HORSHAM DISTRICT COUNCIL CONSULTATION

TO:	Horsham District Council – Planning Dept
LOCATION:	Barns Green Stores Chapel Road Barns Green Horsham
DESCRIPTION:	Application for Approval of Details Reserved by Condition 5 and 6 to approved application DC/19/2052
REFERENCE:	DISC/24/0288
RE-CONSULT:	1st set of comments in black 2nd set of comments in blue 3rd set of comments in green 4th set of comments in purple 5th set of comments in pink
RECOMMENDATION:	More Information More Information More Information Advice No objection

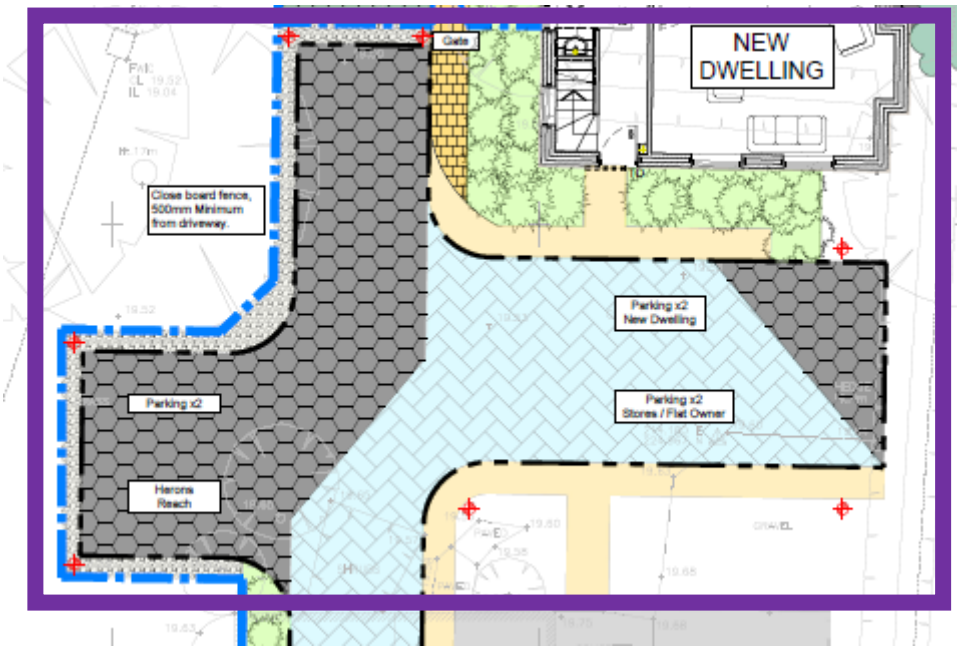
We note now, however, that the desired layout of limestone chippings (no-dig) and permeable paving may look unsightly, therefore we would advise that the area within the purple box below is proposed as a uniform permeable surface that can be installed as a 'no dig' paving system. At minimum, we recommend achieving a uniform appearance by ensuring that the colour palette for the proposed treatments are similar or matching. In addition, the no dig area should extend to the western boundary in order to protect the RPA of TPO'd T5.

Amended, with thanks. Closed.
